Port of Gaspé – Sandy Beach Sediment Remediation Project

Environmental Impact Assessment filed with the with the Quebec Ministry of Sustainable Development, Environment, Wildlife and Parks (MDDEFP)

Addendum

September 2012
O/Ref.: 045-P001130-0162-EI-0200-00

Appendix 3 Location of the Turbidity Curtain

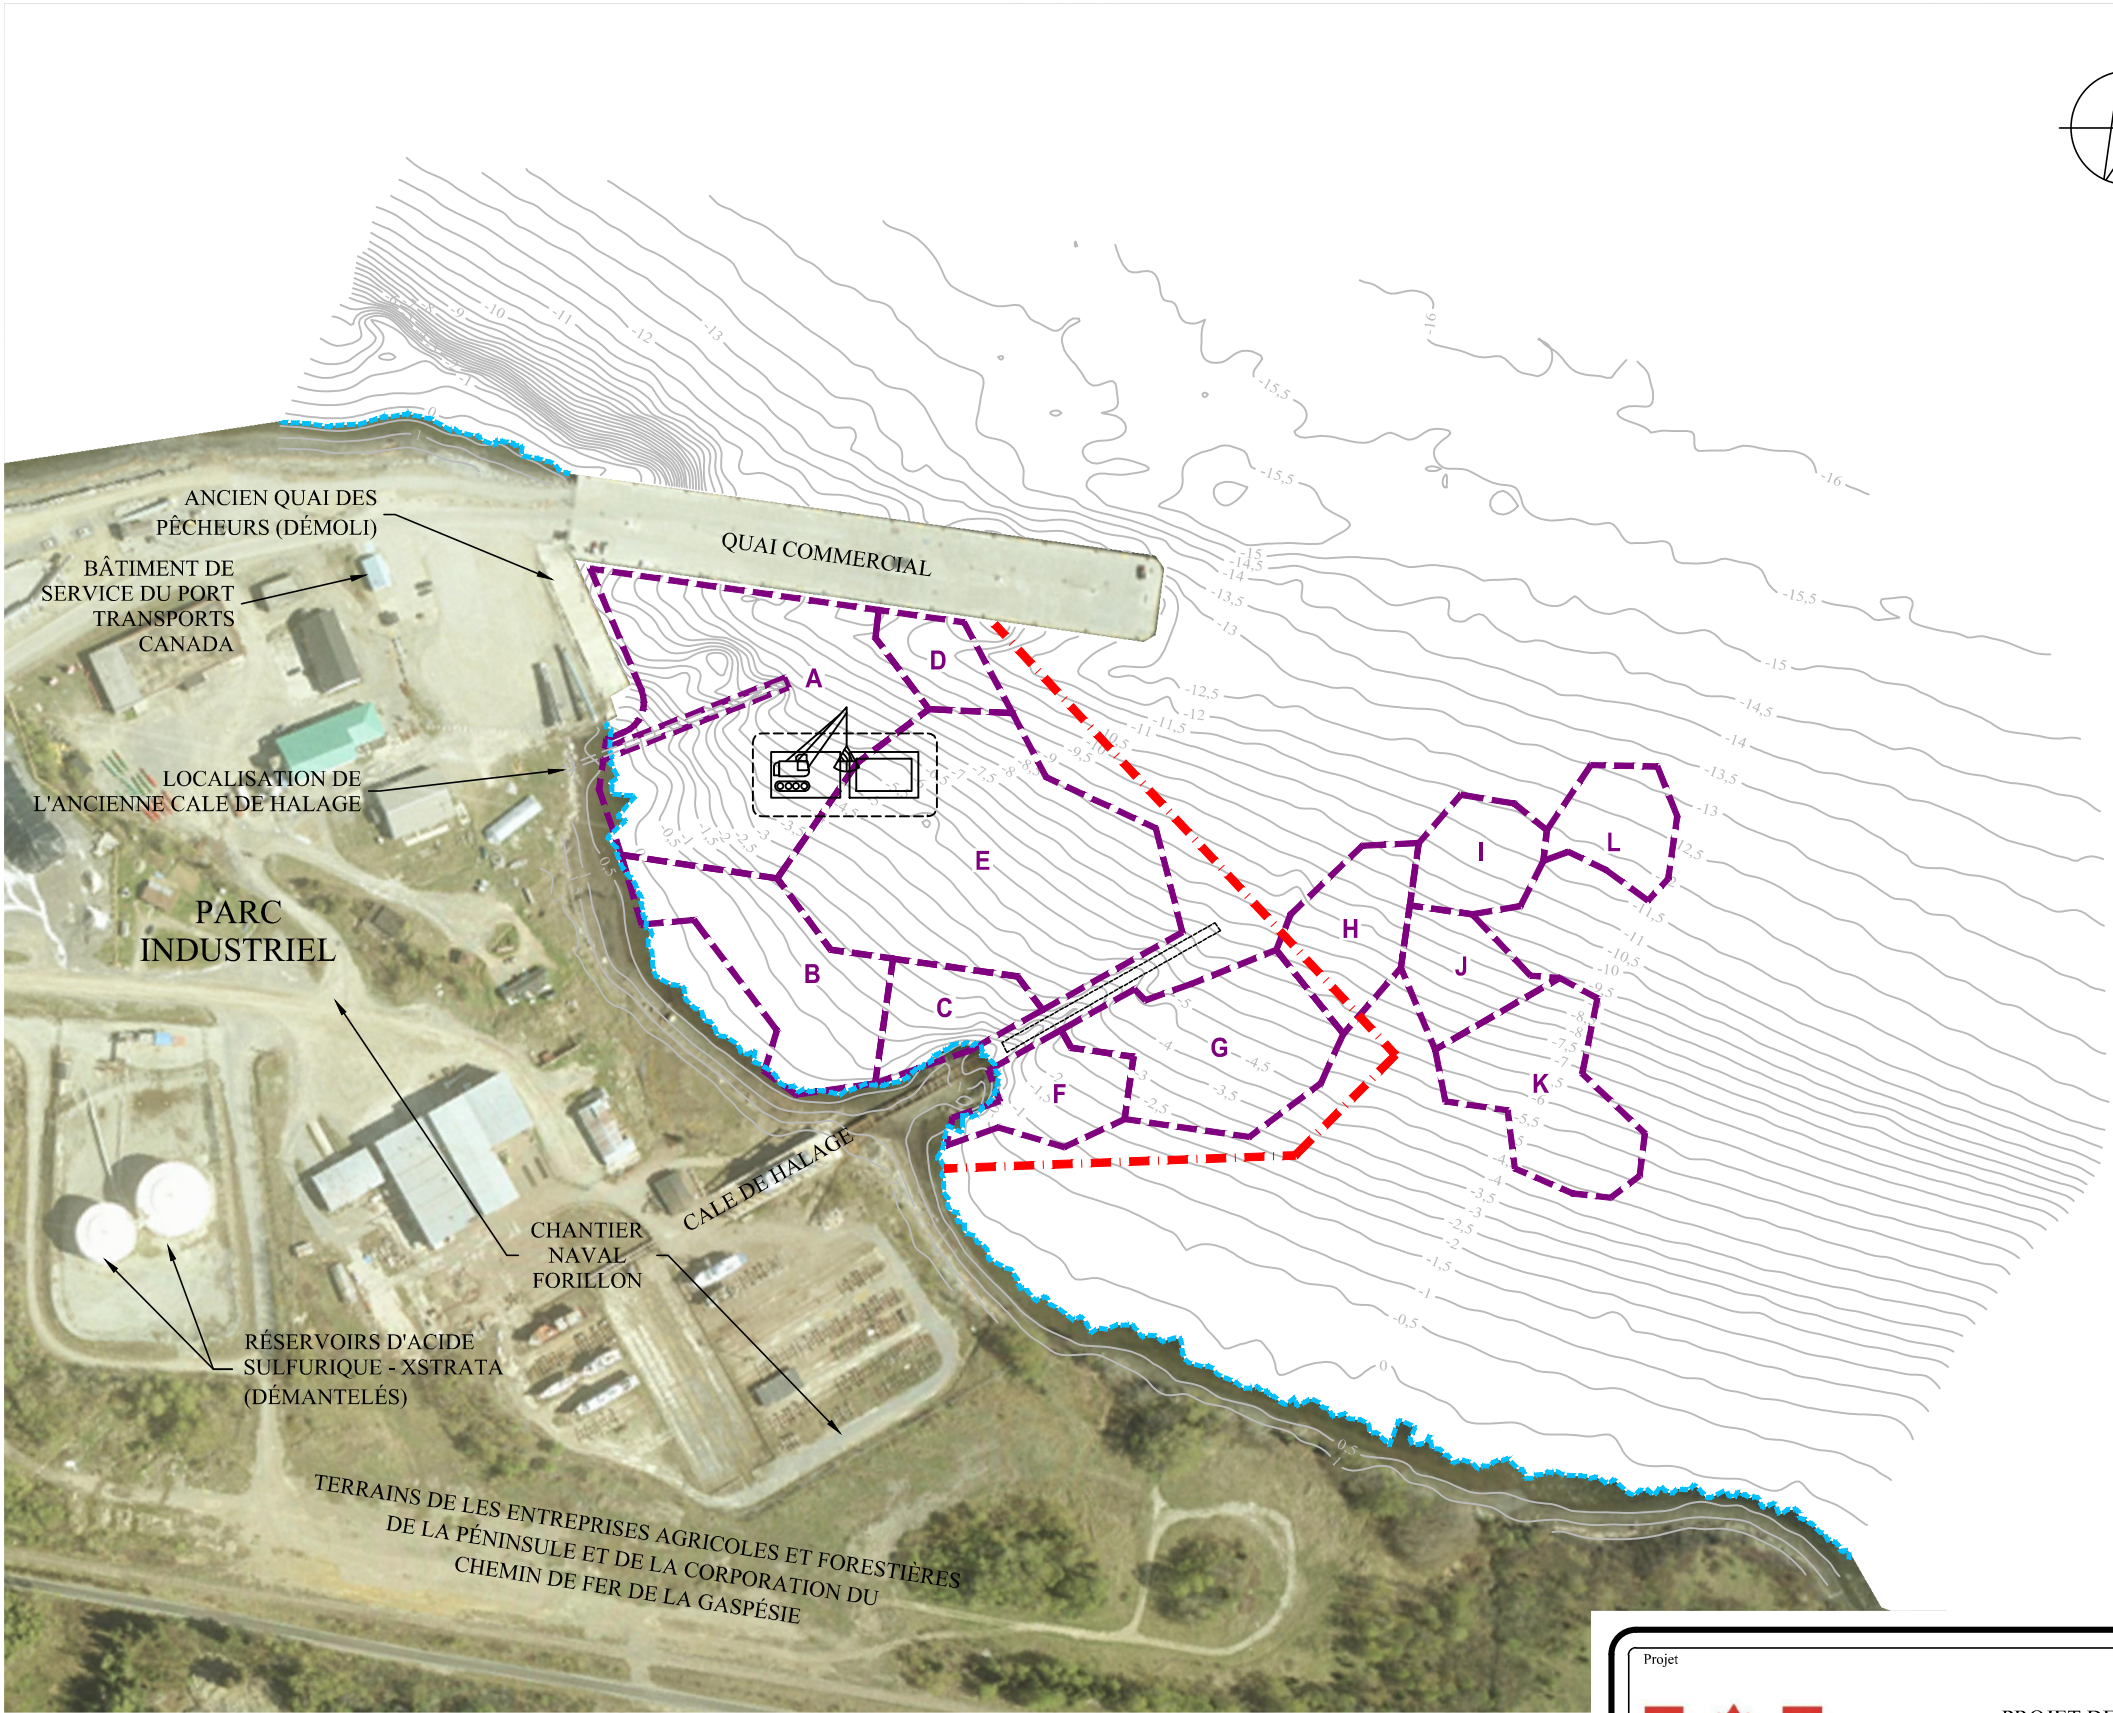
The turbidity curtain will be mandatory for Zone A (see Appendix 2), the most contaminated zone. For the other zones, installing a curtain or any other structure or method approved by TC will be at the Contractor's discretion. However, the Contractor must, at all times, respect the SPM criterion at the control point in the bay of Gaspé (150 m from the dredging equipment or the turbidity curtain), verified by turbidity measurement as set out in the Protocol. The figure in Appendix 3 shows an example of how the turbidity curtain could be installed, presented for informative purposes only. This layout was produced solely for the project's design and is not based on any hydrodynamic data (currents, waves, tides). Once this data is examined, the presented installation may not be feasible. The turbidity curtain as illustrated will be anchored to the commercial wharf at its northern end and to the shore at its southern end. The curtain will be held in place by a series of anchor pairs installed at the seam of each 15 m section (one pair per seam).

Appendix 4 Location of the Temporary Landing Pier

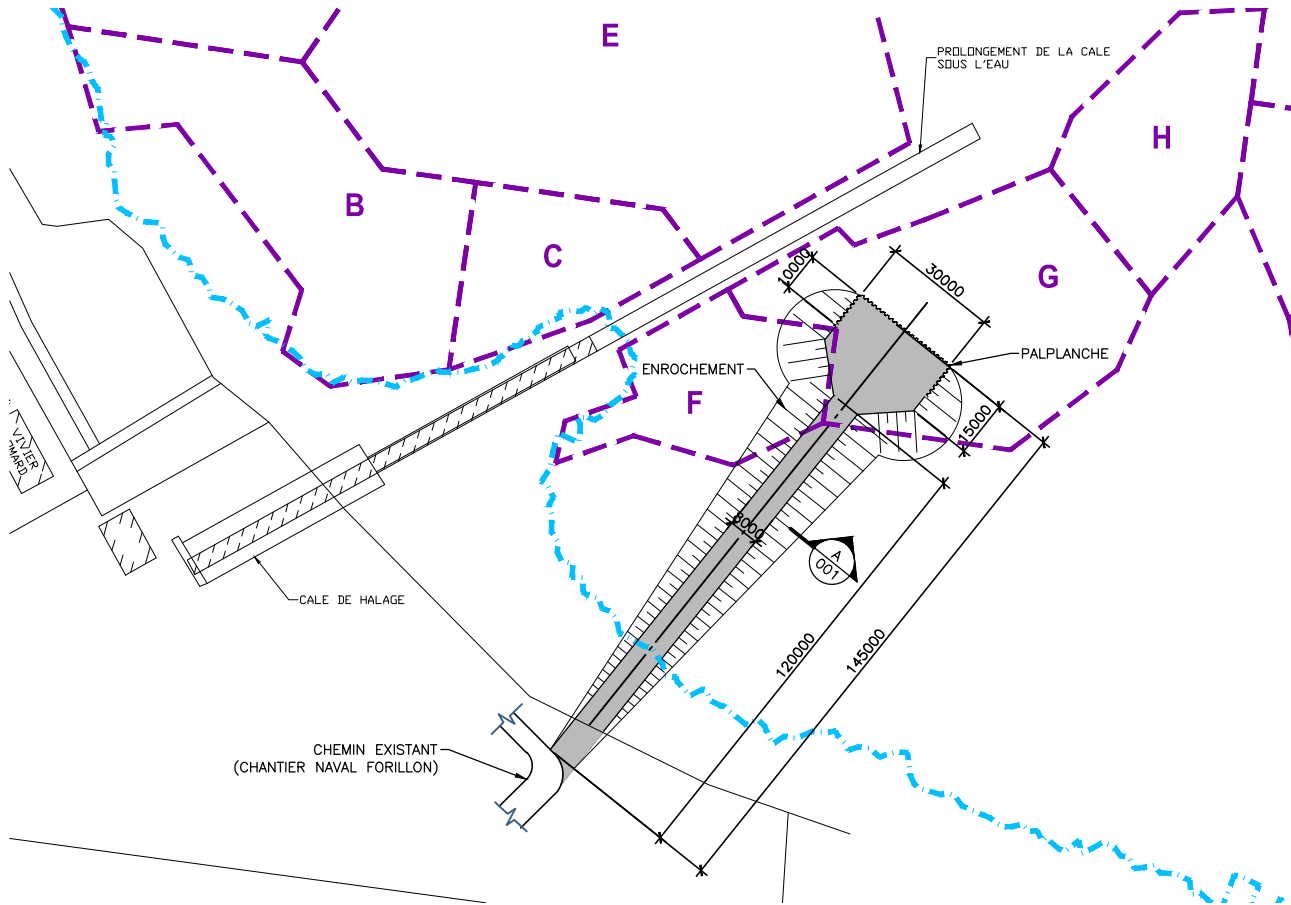
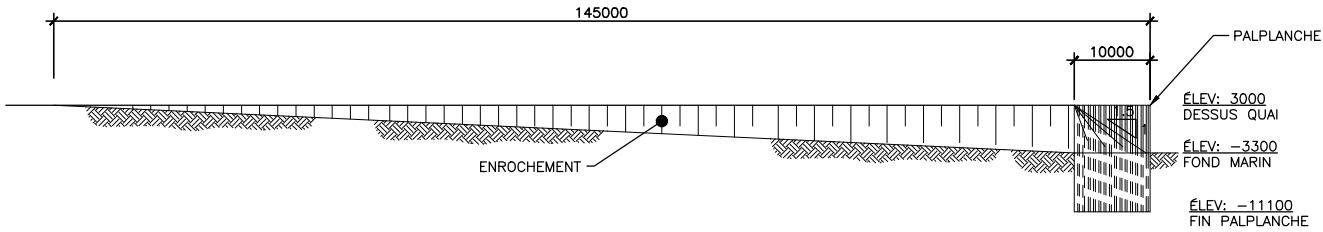
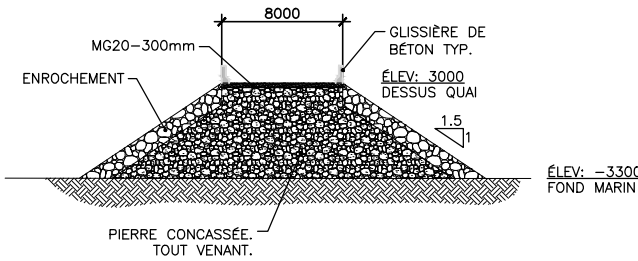
QC-9: With reference to Section 2.5.2.3, on transporting the sediment, the project proponent must determine the most suitable location for the temporary landing pier and access road, which may be required if the mechanical dredging option is chosen. The proponent must provide a description of the landing pier infrastructure, including its dimensions, assess the associated impacts and determine the necessary mitigation measures. What measures will be taken with regard to the presence of contaminated sediment at the landing pier site? Does the site reclamation work include managing the contaminated sediment at this location?

If a temporary landing pier is required, it must be built with contamination-free material inside the intervention area. The transshipment area must be located in the dredging area, however. For informative purposes, the figure in Appendix 4 shows the location of a jetty used as a temporary landing pier, including its dimensions.

In applying for the certificate of authorization, TC must present the Contractor's drawings and intended work method, including the building and dismantling of the temporary landing pier. The Contractor will explain how it plans to avoid mixing the material it will use to build the pier with the contaminated sediment in the bay. It must also present the method it will use to remove the contaminated sediment (whose concentration exceeds the IEL) from the pier's footprint in the dredging area. If required during the dismantling work, the rock fill must be cleaned prior to final management. In its application for authorization, TC will present the expected impacts associated with building this structure and the mitigation measures that must be applied.
